16 July 2025

**RE: Request to Amend Regional Interest Development Approval
RPI25/001 Anglo American – Planet Downs Project (Access Tracks)**

Figure 1 RIDA Attachment 1 – Approved Plan

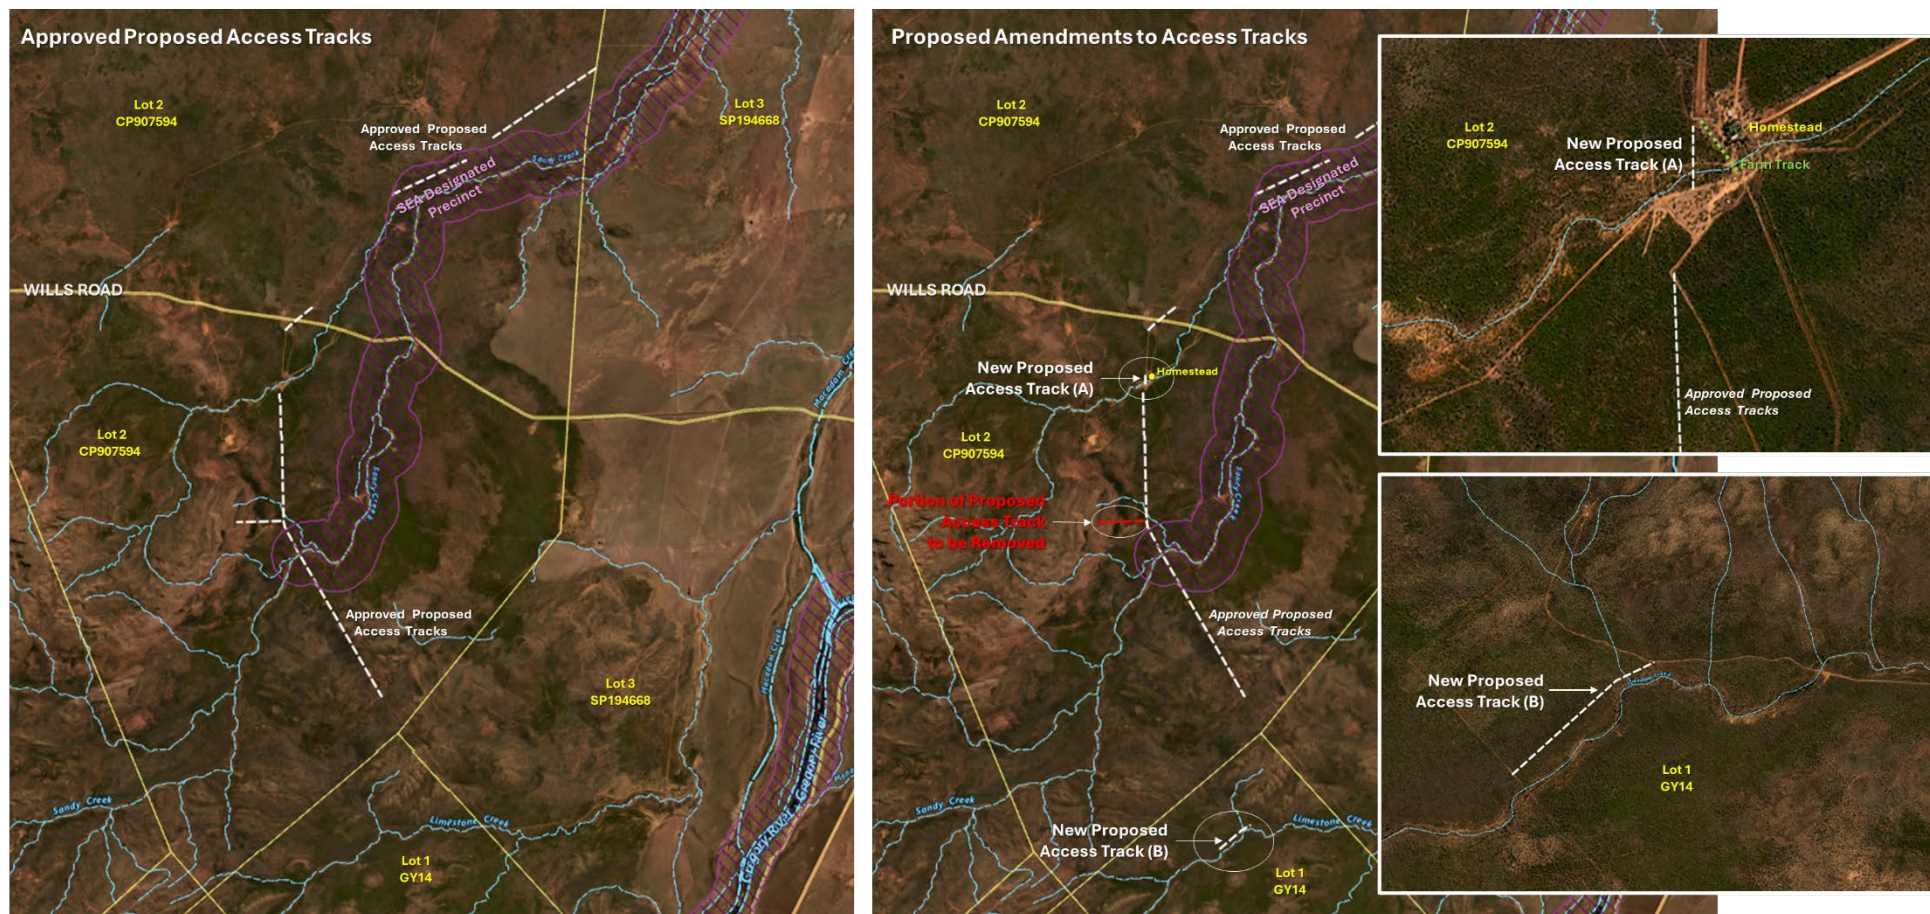
As described in the RIDA Supporting Report and as shown on Attachment 1 – Approved Plan of the RIDA (refer **Figure 1**), the RIDA application included the proposed construction of up to 20 kilometres (km) of temporary access tracks (of up to 3 m wide) to support Anglo's exploration activities within the SEA. The total area of disturbance for the proposed access tracks is 6.0 ha, which is inclusive of 1.4 ha of disturbance within the SEA Designated Precinct.

Since the submission of the RIDA application in February, the landowner of Lot 2 CP907594 has requested a preference for Anglo to not utilise a farm track in the vicinity of a homestead, and to instead to create a small temporary access track approximately 100 m to the west of their property (refer to "New Proposed Access Track (A)" on **Figure 2**). In addition, Anglo has undertaken further desktop assessments and analysis, and determined that one of the proposed access tracks is better located to the south of the site (refer to "New Proposed Access Track (B)" on **Figure 2**).

The portion of track to be removed is approximately 1.4 km in length, which is of a comparable size to the new proposed tracks, with the New Proposed Access Track (A) being approximately 250 m in length, and the New Proposed Access Track (B) being approximately 1.2 km in length. The two new access tracks are not located within the SEA Designated Precinct (**Figure 2**).

Figure 3 Proposed Drainage Line Crossing Points (indicative locations shown as red dot)

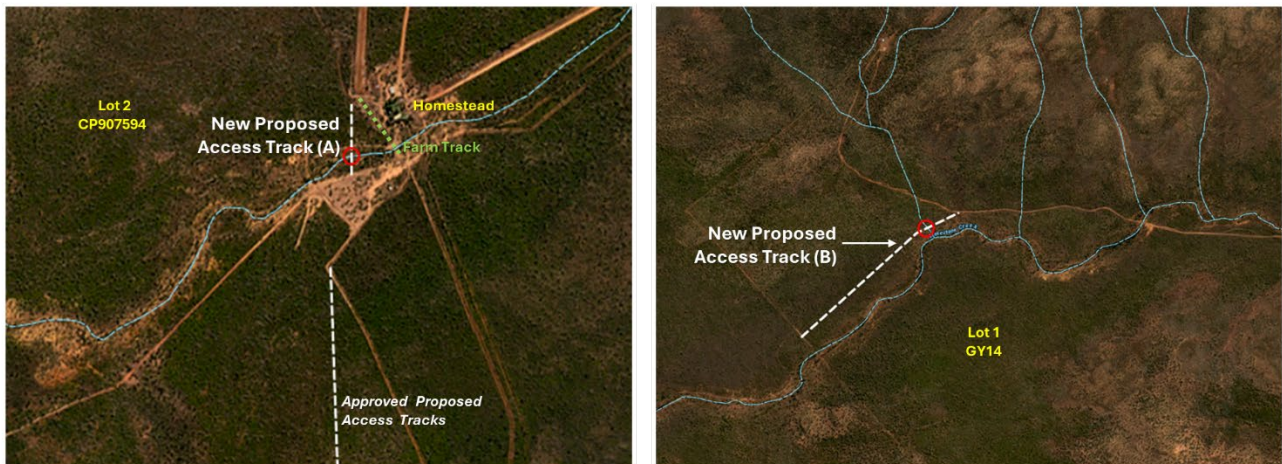
The New Proposed Access Tracks will traverse mapped waterways at two locations, namely an unnamed tributary of Limestone Creek of stream order 2, and an unnamed tributary of Sandy Creek of stream order 3 (refer **Figure 3**). These tributaries are ephemeral minor drainage lines and unlikely to support riparian vegetation. The activities are not proposing to construct any waterway crossings at these locations, nor remove any riparian vegetation. Activities will be undertaken during the dry season. The proposed activities are temporary and unlikely to interfere with the natural hydrologic or geomorphic processes of either Limestone or Sandy creeks, their tributaries, nor of the SEA.

Figure 4 Amended Proposed Temporary Access Tracks in relation to Existing Farm Tracks, Mapped Waterways and SEA Designated Precinct

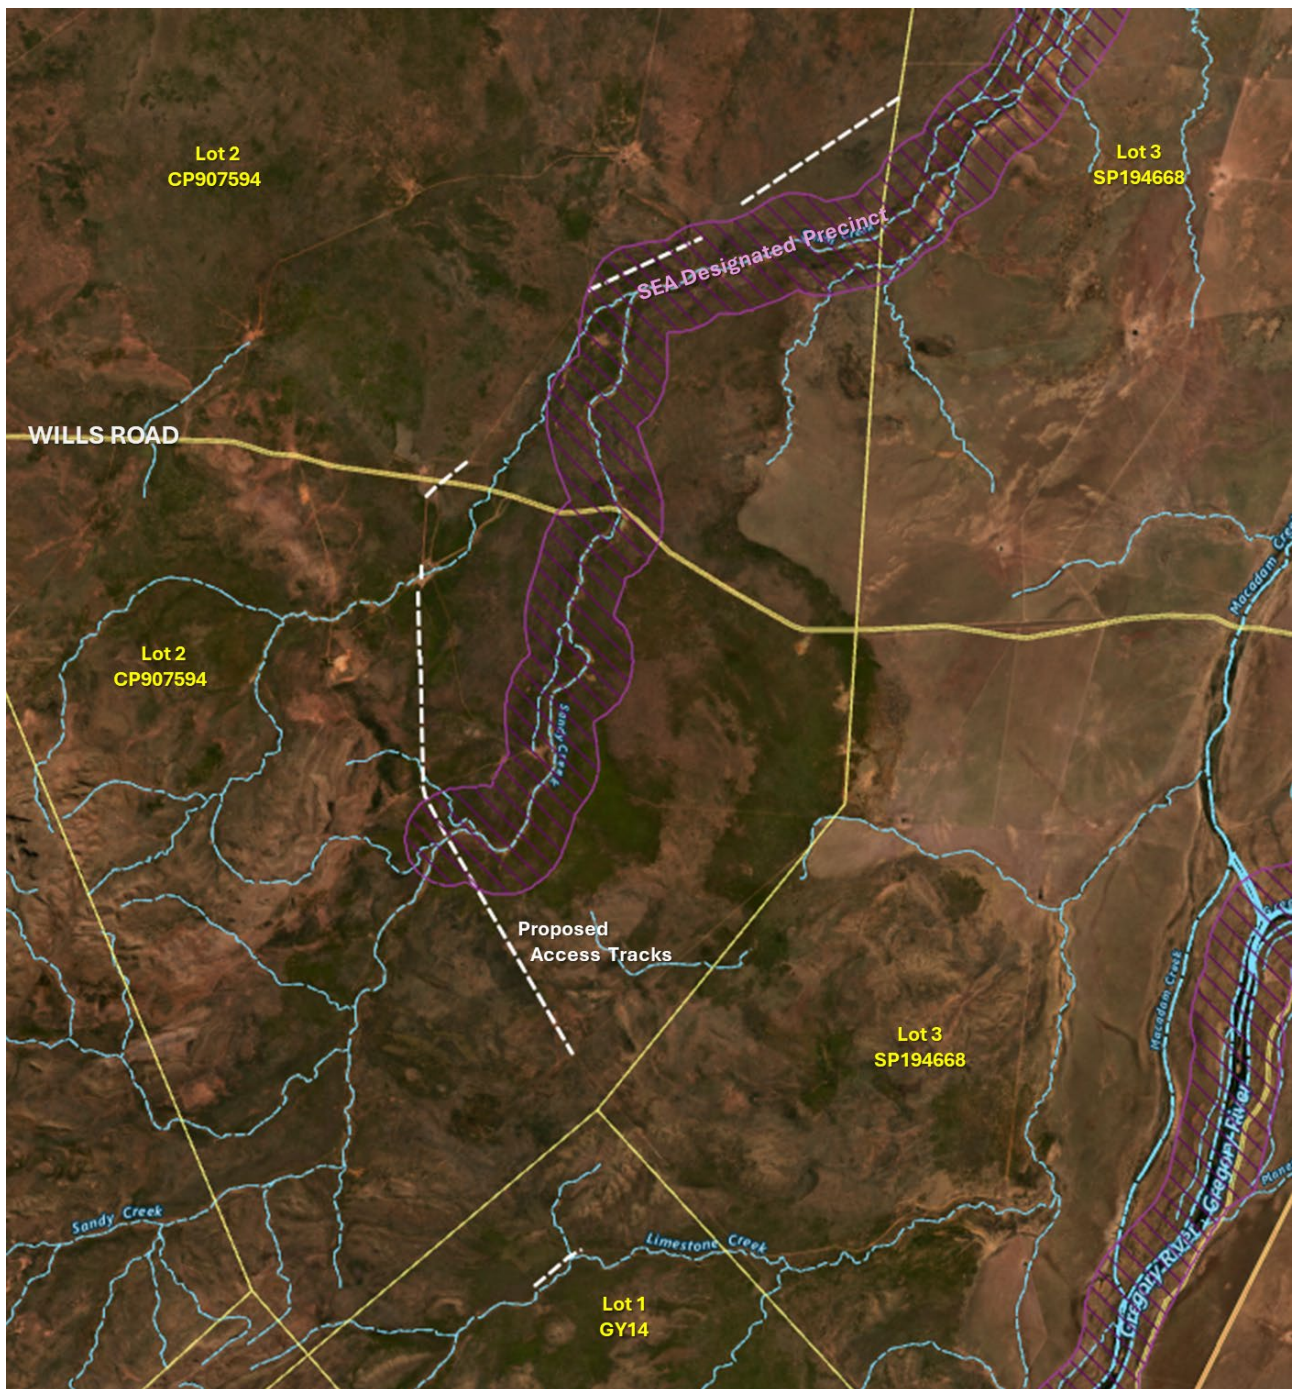
- *Description of the Land:*
 - Real Property Description to be amended to include Lot 1 on GY14 as follows:
Lot 2 on CP907594, Lot 3 on SP194668 and Lot 1 on GY14
- *Table 1: Approved Resource Activity:*
 - Location to be amended to include Lot 1 on GY14 as follows:
Lot 2 on CP907594, Lot 3 on SP194668 and Lot 1 on GY14
- *Attachment 1 – Approved Plan:*
 - A revised figure to be included as Attachment 1 – Approved Plan is provided at **Figure 4**.
- *Condition 1(c):*
 - Suggested amended wording for condition 1(c), which references the figure provided in the RIDA application document, is provided as red text in **Table 2**.

Only four components of the RIDA require amending, namely the real property descriptions provided in the Description of the Land and in Table 1 Approved resource activity, Attachment 1 – Approved Plan, and Condition 1(c) (which references the figure provided in the RIDA application document).

No.	Current RIDA Conditions	Suggested Revised Conditions
1.	<p>Carry out the approved resource activity in the Gulf Rivers SEA generally in accordance with:</p> <p>(a) the resource activity identified in Table 1: Approved resource activity</p> <p>(b) the resource activity as described in Table 2: Description summary of the proposed resource activity in the Gulf Rivers SEA</p> <p>(c) Plate 3.1 Proposed Temporary Access Tracks in relation to existing farm tracks, SEA and SEA Designated Precinct (Attachment 1) as provided in the submitted RPI25/001: Anglo American – Planet Downs Project (Access Tracks) Response to Requirement Notice of 17 February 2025, dated 24 February 2025.</p>	<p>Carry out the approved resource activity in the Gulf Rivers SEA generally in accordance with:</p> <p>(a) the resource activity identified in Table 1: Approved resource activity</p> <p>(b) the resource activity as described in Table 2: Description summary of the proposed resource activity in the Gulf Rivers SEA</p> <p>(c) Figure 4 Amended Proposed Temporary Access Tracks in relation to Existing Farm Tracks, Mapped Waterways and SEA Designated Precinct (Attachment 1) as provided in the Request to Amend Regional Interest Development Approval - RPI25/001 Anglo American - Planet Downs Project (Access Tracks), letter from Umwelt to DSDIP, dated 16 July 2025.</p>
